DESIGNED BY DLF
DRAWN BY DLF
CHECKED BY QNA
H-SCALE AS SHOWN
V-SCALE N/A
JOB NO. 2604.00
DATE ISSUED 04/03/26
SHEET NO. 2 OF 36

WATERBURY SANITARY FORCE MAIN
UTILITY CONSTRUCTION SET
LEGEND SHEET

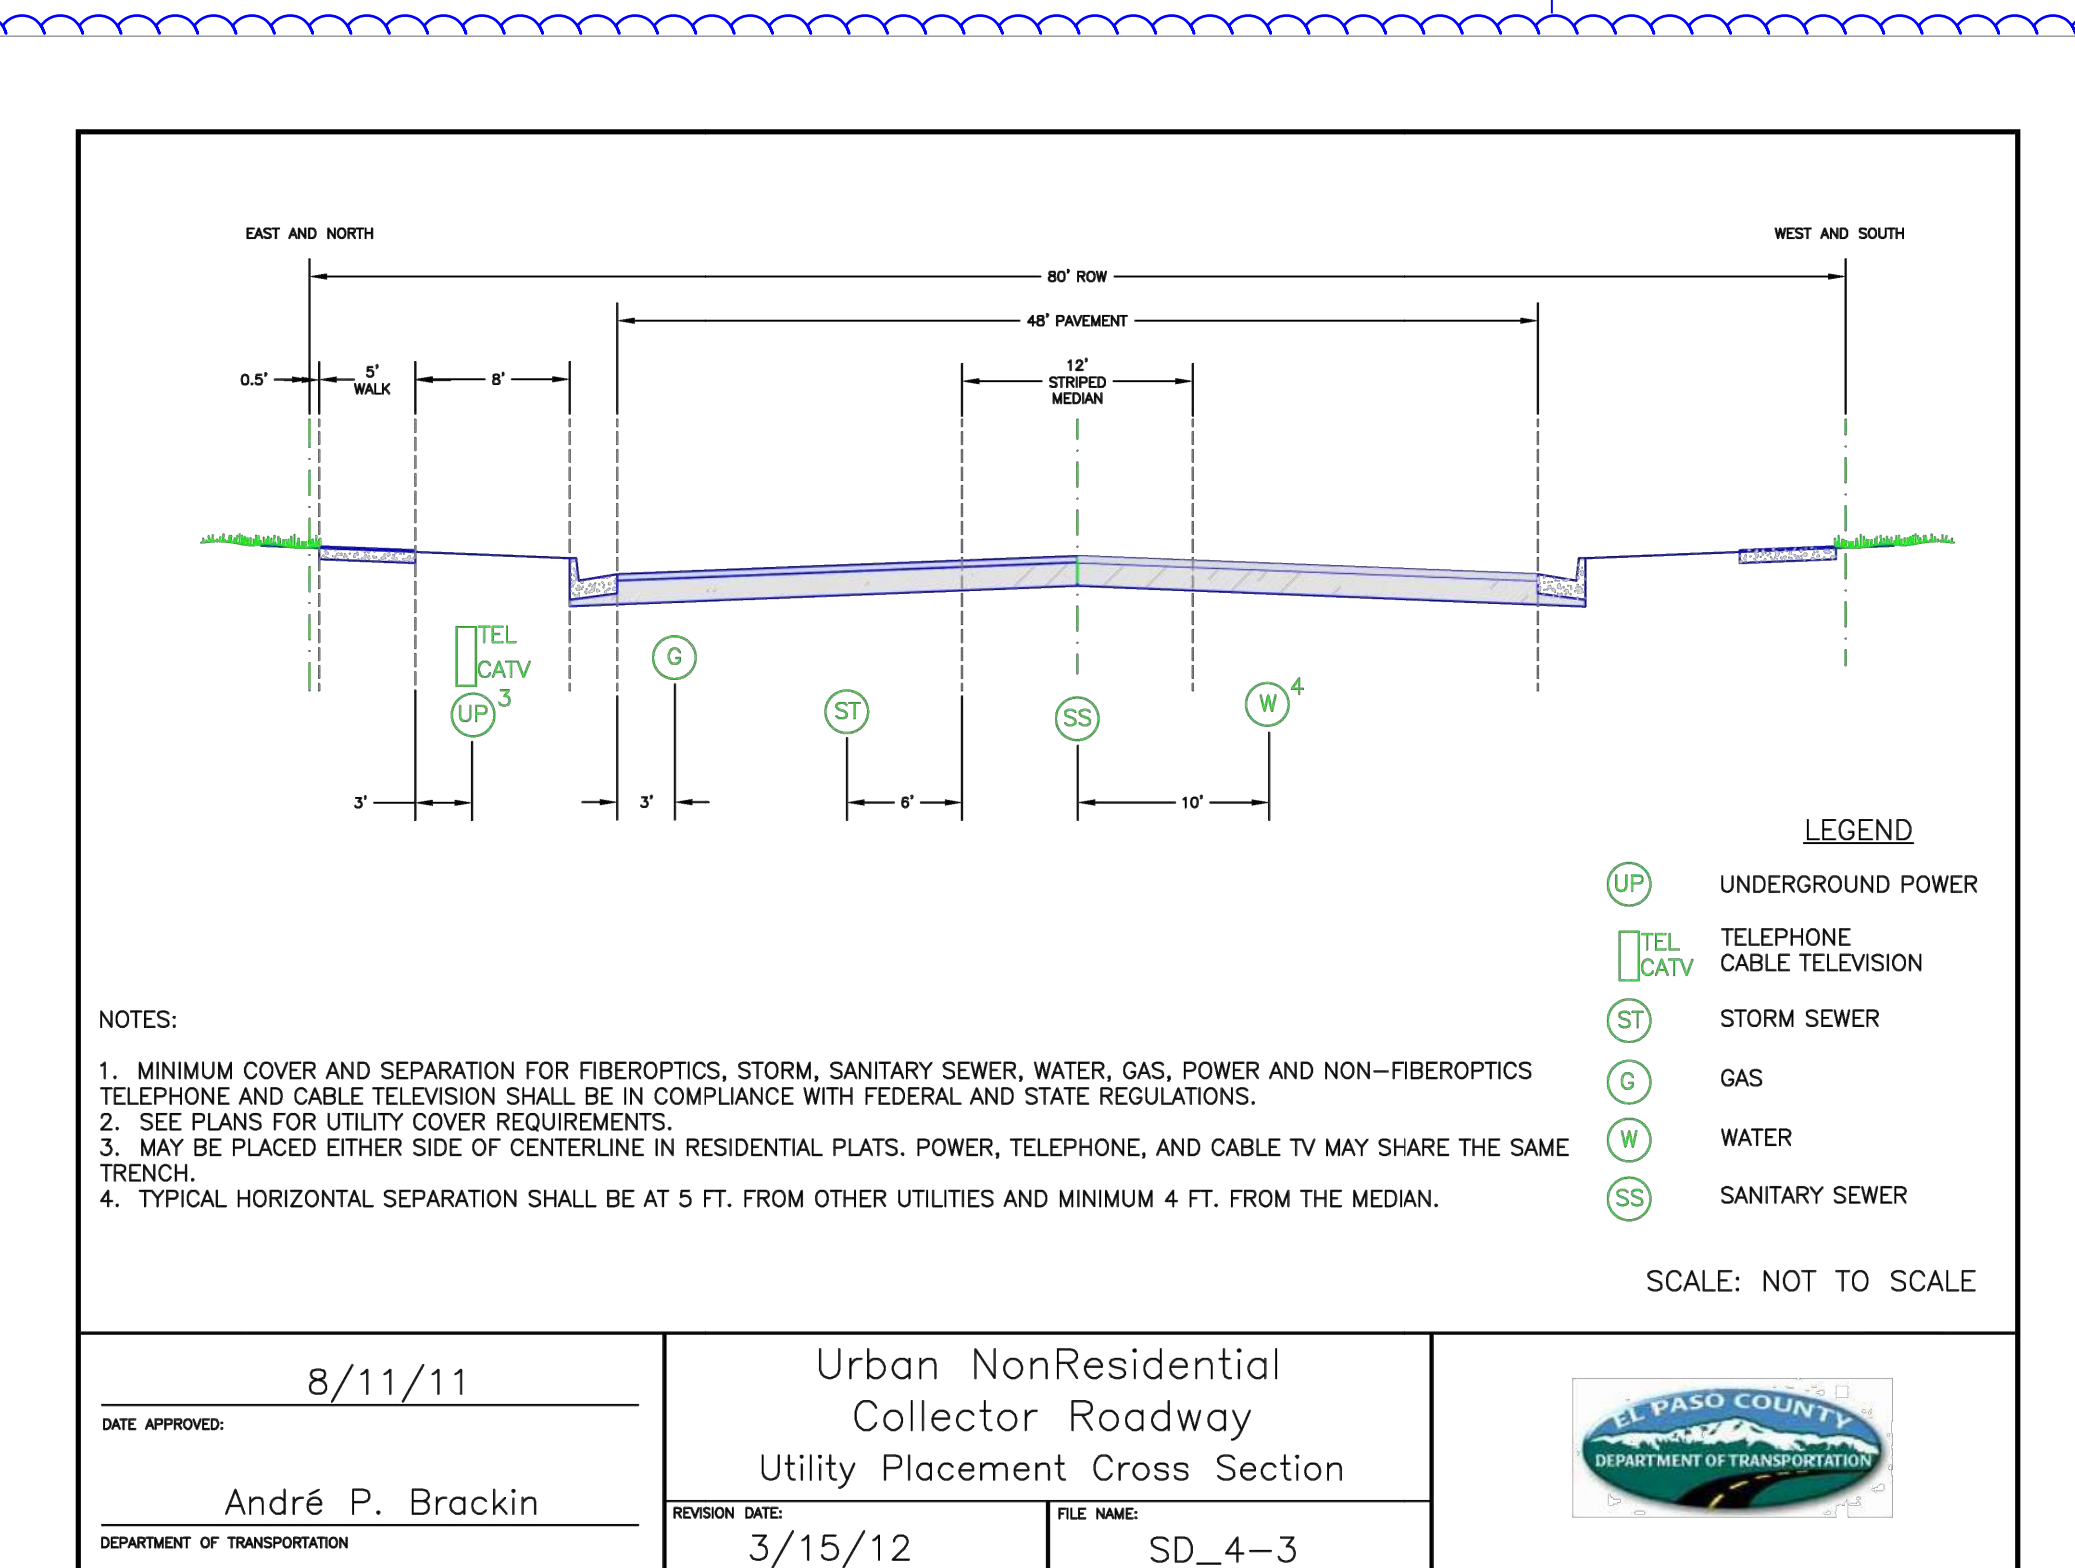
Resolved - dotsaleh
Waterbury is building the force main and the force main is located on either Waterbury owned land or ROW. Where would there be temporary construction easements?

Resolved - dotsaleh
Define proposed FM temporary construction easement line/s.

Resolved - dotsaleh
Define proposed FM temporary easement line/s.

Submit all recorded easements as applicable.

Resolved - dotsaleh
Replace this data 06/16/2026 2:01:31 PM

Unresolved - dotsaleh
Define paved streets and streets (crossings or parallel streets) on all sheets (a gray shaded symbol would work).

Typical comment: Define New Asphalt for Proposed Street and show and label them on the plan layouts to all applicable sheets.

Noted. The data is not yet.

WATERBURY SANITARY FORCE MAIN
 UTILITY CONSTRUCTION SET
 SANITARY FORCE MAIN PLAN & PROFILE

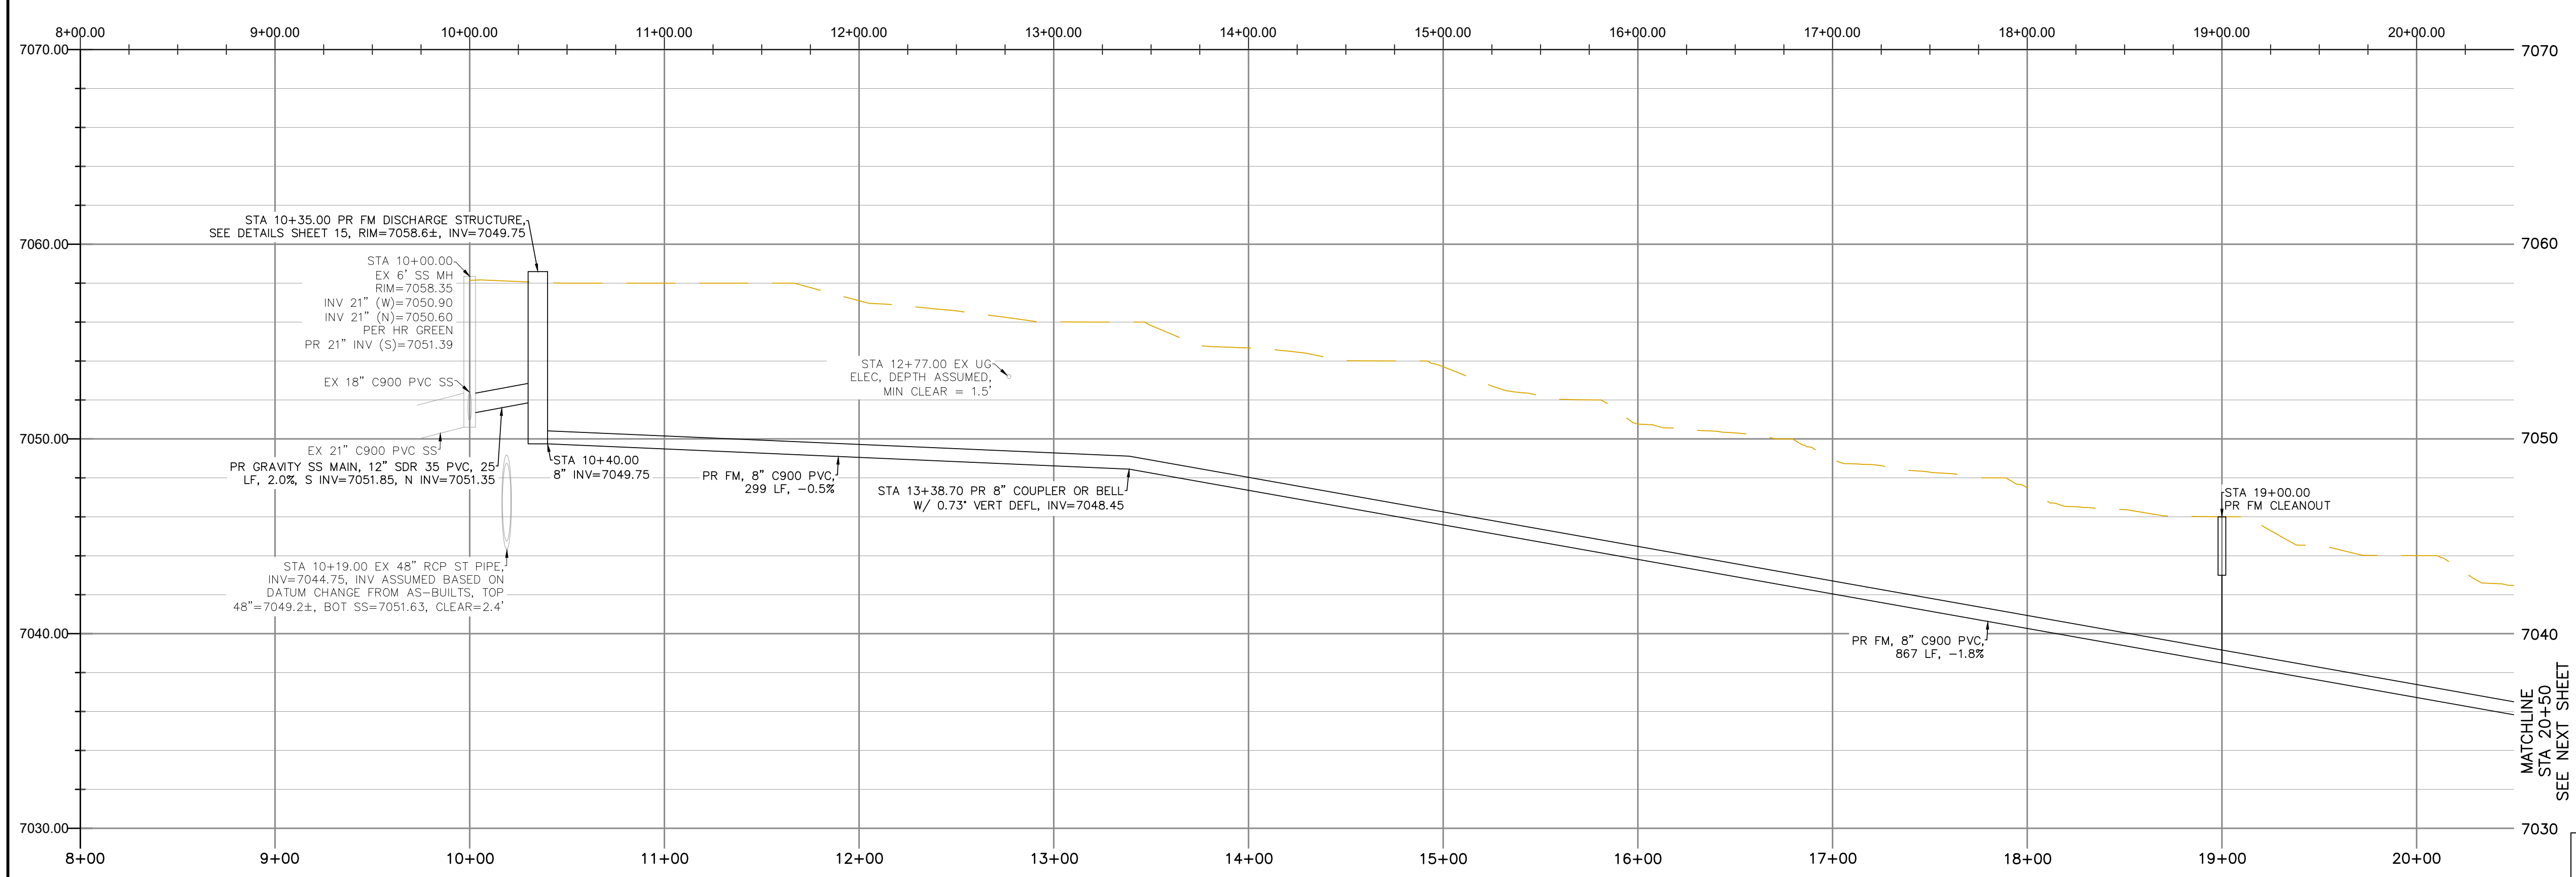
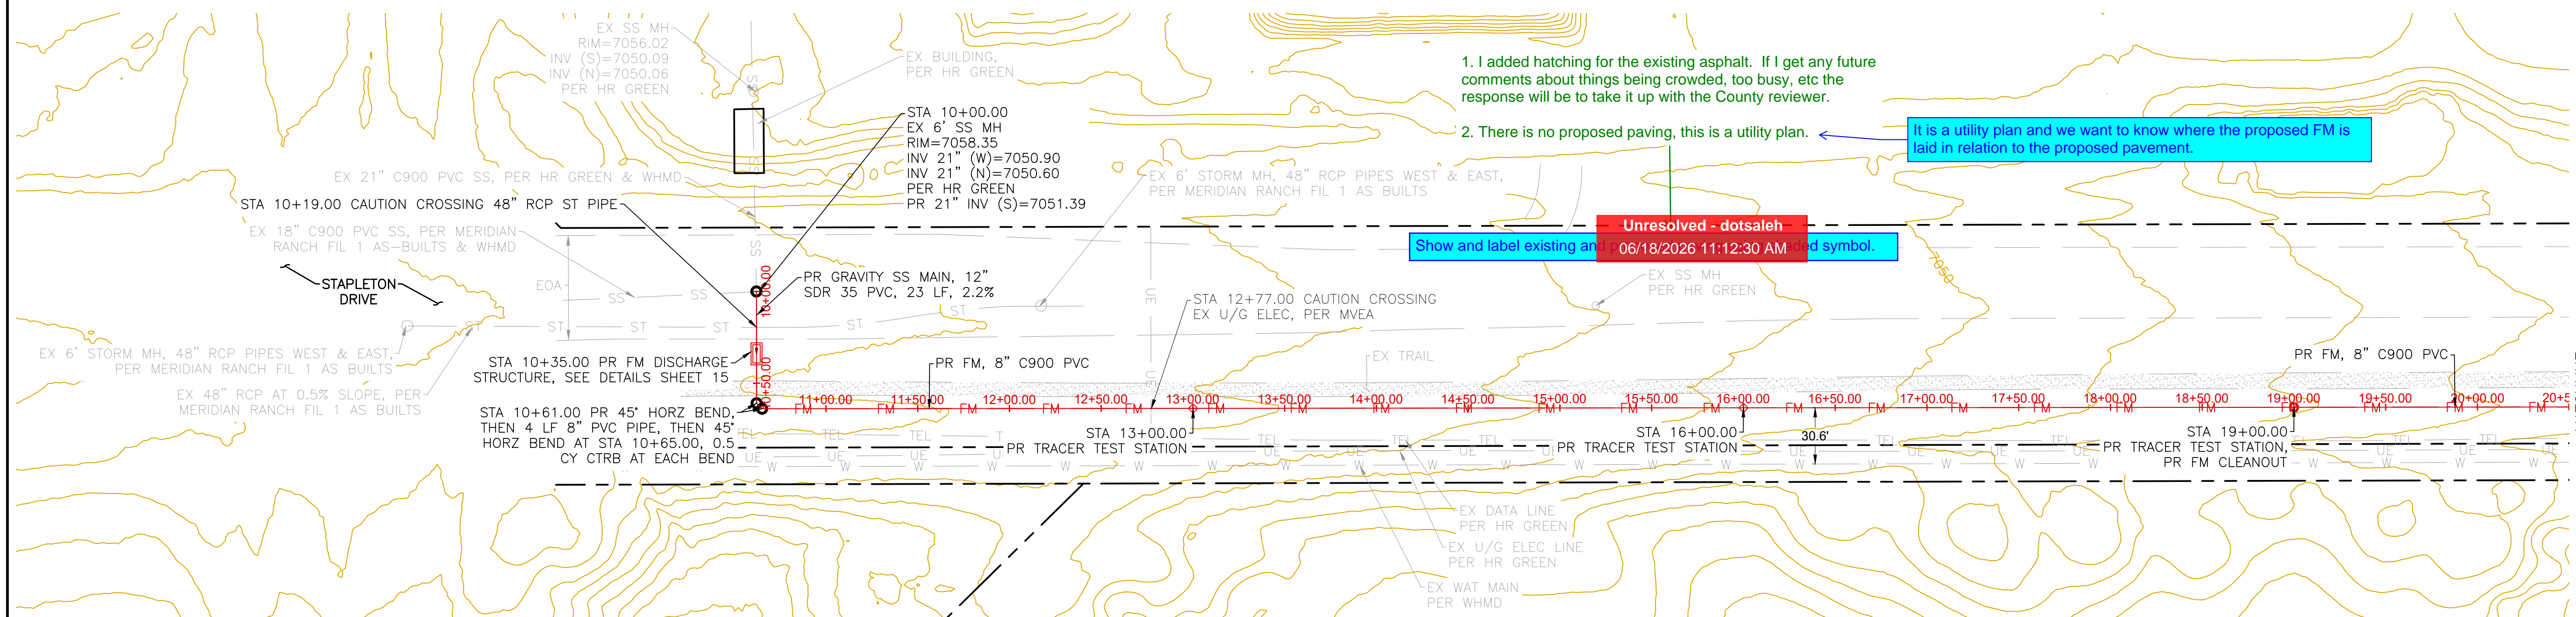
I added this to the cover sheet under notes.
 Add the following note: "the open cut shall not exceed 250 LF per day, the developer can not block the road. The developer can not block it at the end of the same day and make it safe to the public (No open cut to remain open after working hours)."
 Resolved - dotsaleh
 06/18/2026 11:11:20 AM

I added this to the cover sheet. Resolved. 06/18/2026 11:15:25 AM
 Add the following note "the open cut shall not exceed 24" E per day, the developer can not open ground if he/she can not back fill it at the end of the same day and make it safe to the public (No open cut to remain open after working hours)".

Typical comment: Indicate the following for each parcel abutting the proposed FM: Parcel number, parcel address and owner name.

Typical comment: Indicate the following for each parcel abutting the proposed FM: Parcel number, parcel address and owner name.

I added this to the overview sheet.

I added this to the overview sheet.
